MARCH 1984 ENGLISH EDITION

GRAND WAGONEER/TRUCK 10-20 SERIES

BROKEN CYLINDER HEAD BOLT

Fig. 1 Bolt Tightening Sequence and Torque Specifications

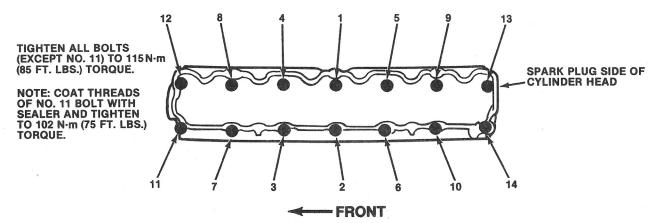
Some bolts used on the spark plug side of the cylinder head in 4.2L in-line six-cylinder engines, were improperly hardened and may break under the bolt head or in the bolt thread area. The engines with suspect bolts are coded as follows:

Whenever a broken bolt is found, all of the bolts on the spark plug side of the head (Fig. 1), should be replaced with new bolts, 400 6593. Six-cylinder engines require seven bolts.

Be sure to follow the bolt tightening sequence and torque specifications indicated in Figure 1 when replacing the bolts.
